CONTRACT CHANGE ORDER NO. 1

AIRPORT Augusta Regional Airport

PROJECT Construct Hangar N1 Apron &
Taxilane – 0119700-202061.03

CHANGE ORDER 1 - RELOCATE (E) TAXIWAY A GUIDANCE SIGN ON NEW PCC BASE AND INSTALL NEW GUIDANCE SIGN ON NEW PCC BASE

Mead
& Hunt
EXHIBIT 1.1

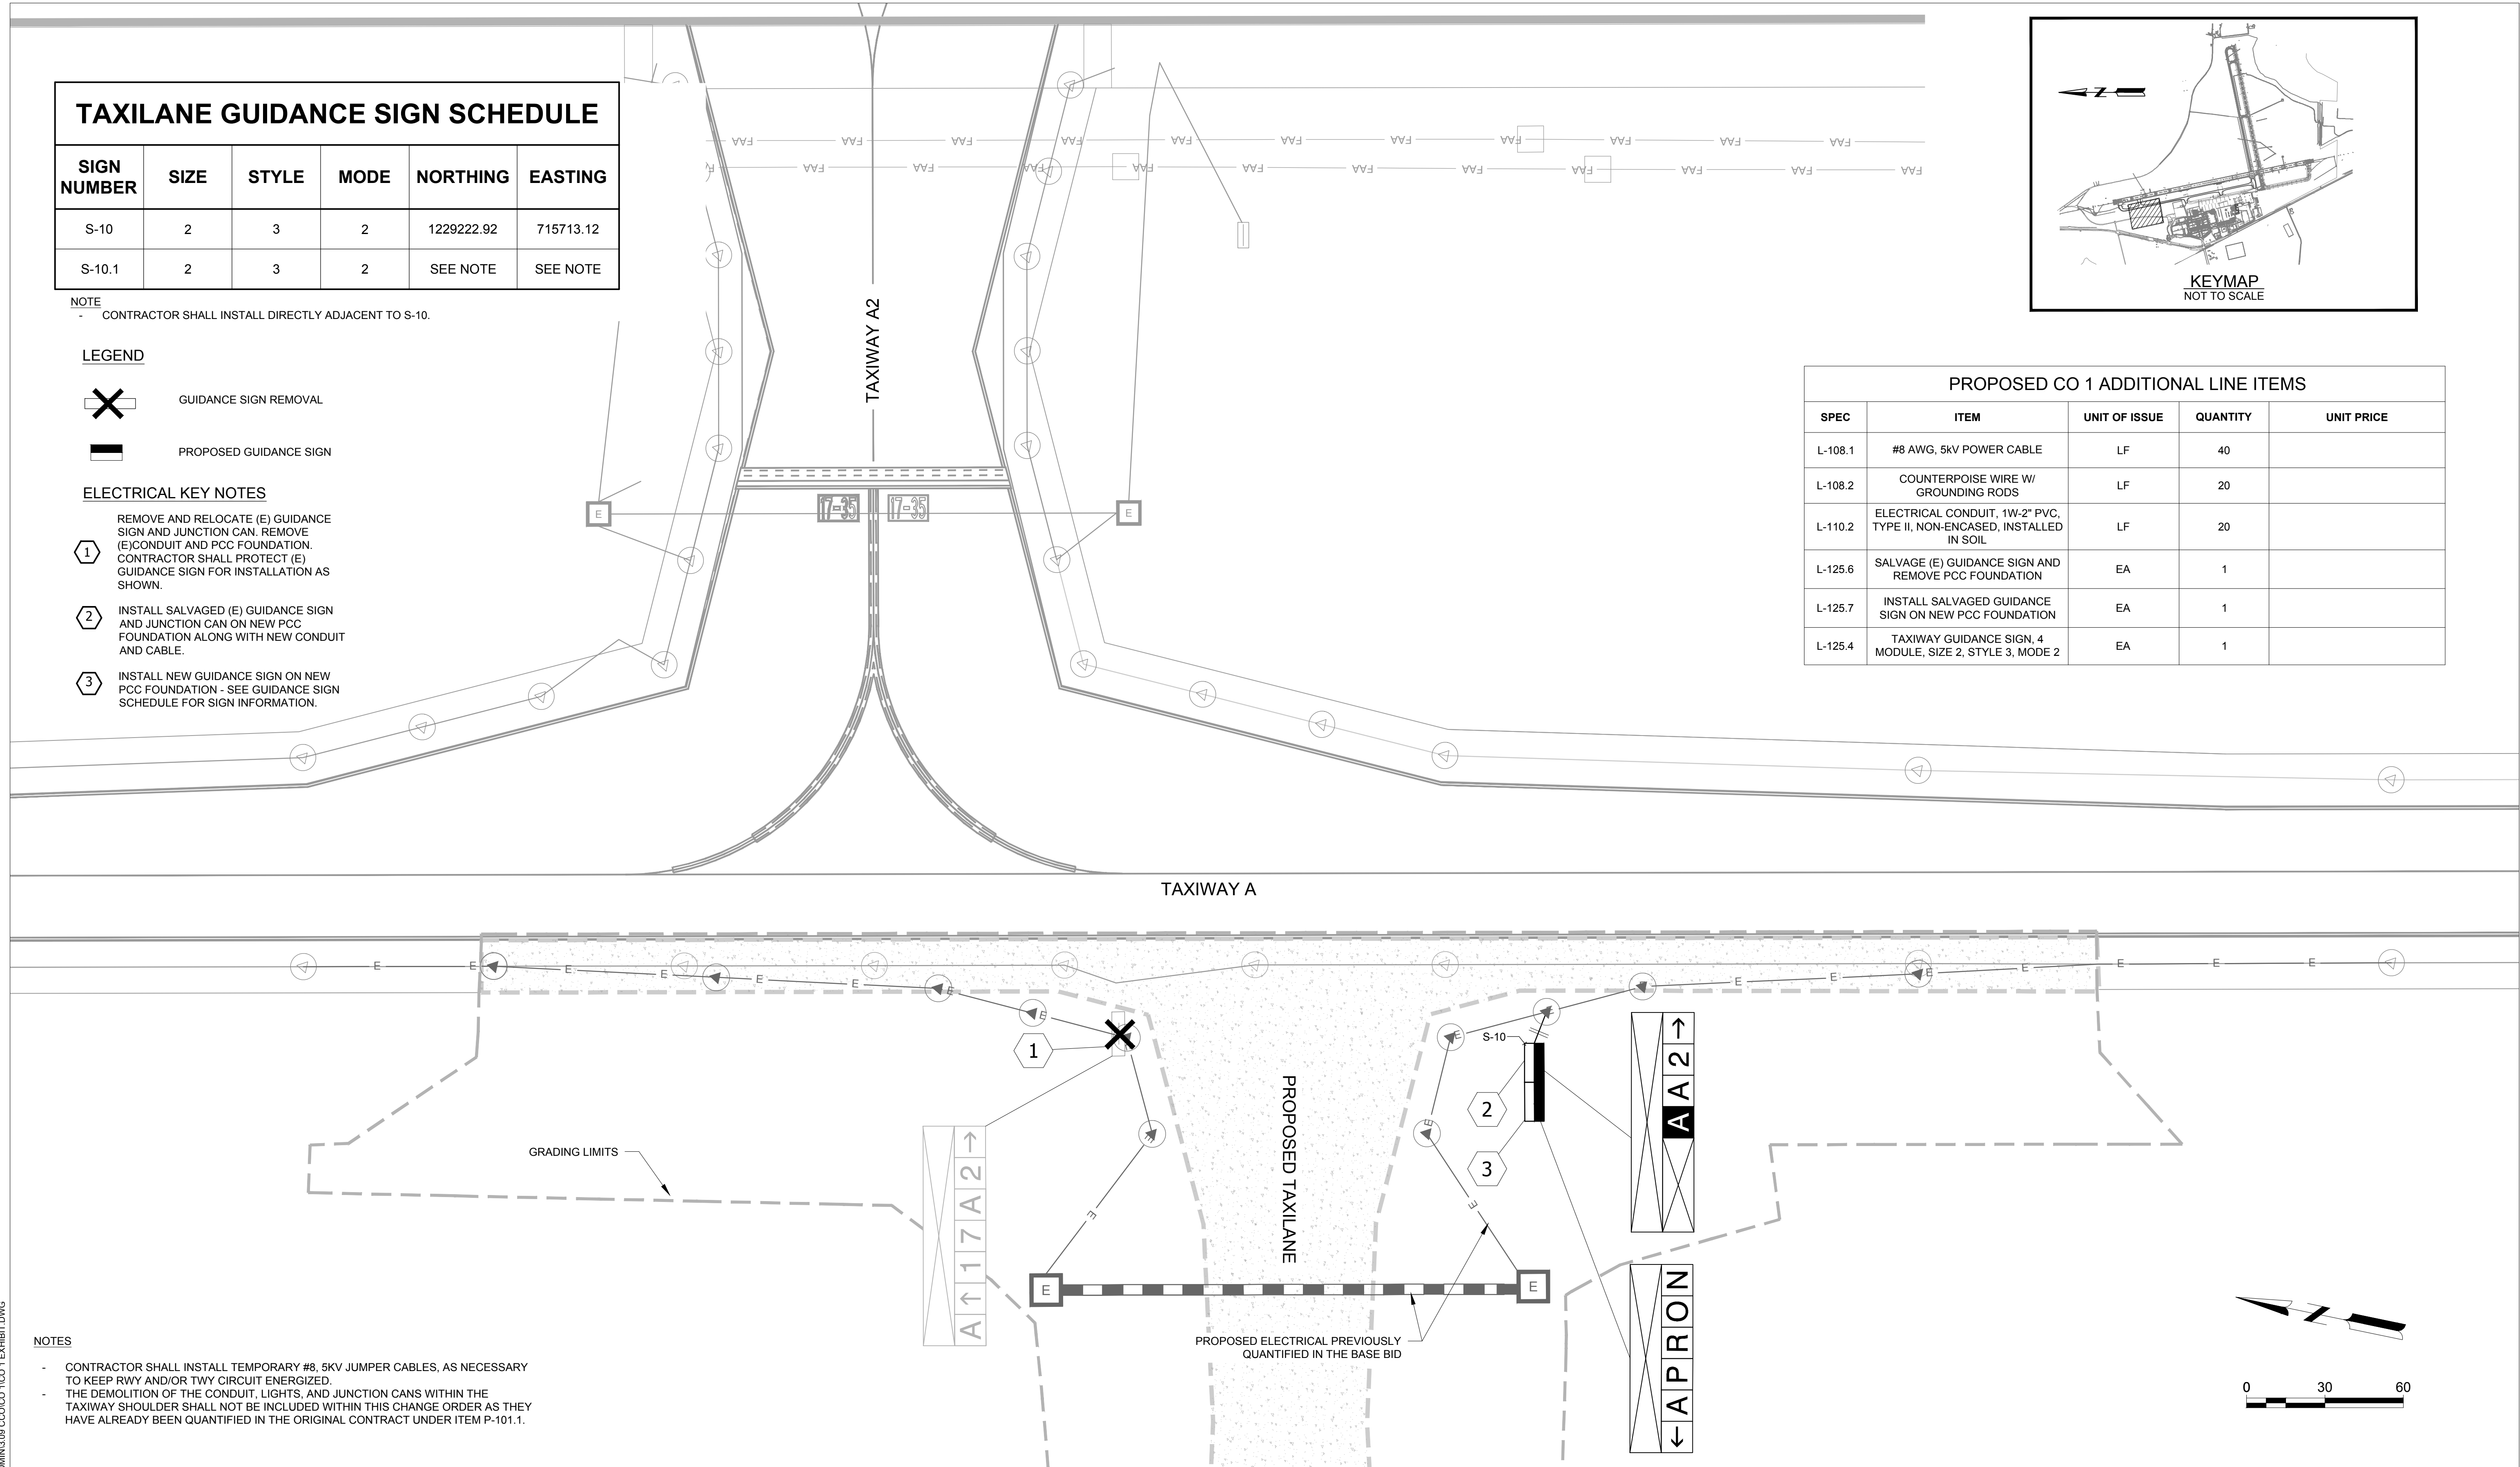
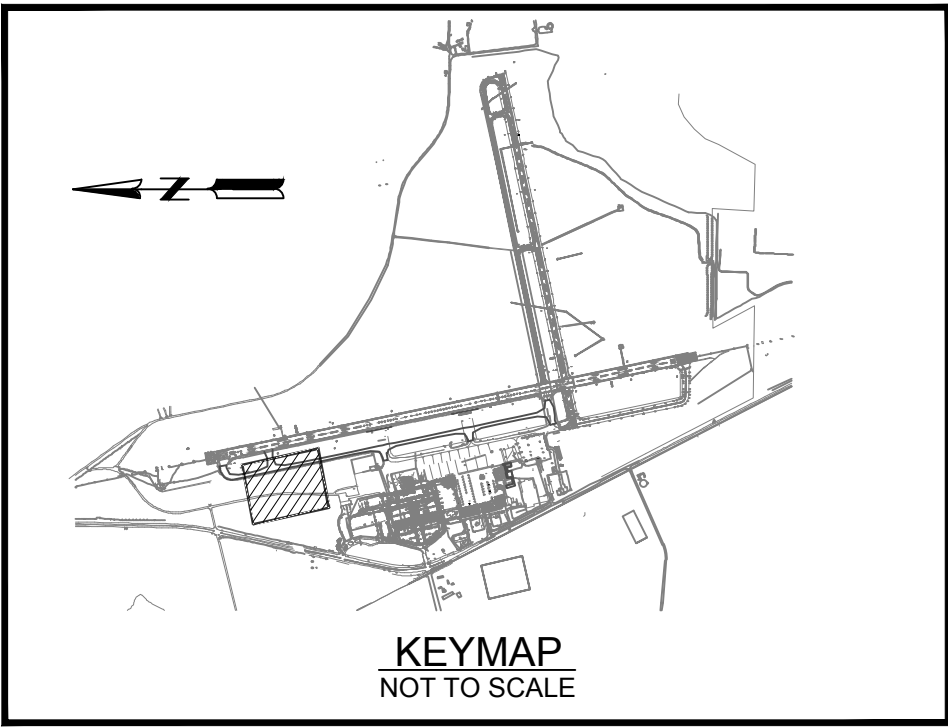
NOTE
- CONTRACTOR SHALL INSTALL DIRECTLY ADJACENT TO S-10.

-  1 REMOVE AND RELOCATE (E) GUIDANCE SIGN AND JUNCTION CAN. REMOVE (E)CONDUIT AND PCC FOUNDATION. CONTRACTOR SHALL PROTECT (E) GUIDANCE SIGN FOR INSTALLATION AS SHOWN.
-  2 INSTALL SALVAGED (E) GUIDANCE SIGN AND JUNCTION CAN ON NEW PCC FOUNDATION ALONG WITH NEW CONDUIT AND CABLE.
-  3 INSTALL NEW GUIDANCE SIGN ON NEW PCC FOUNDATION - SEE GUIDANCE SIGN SCHEDULE FOR SIGN INFORMATION.
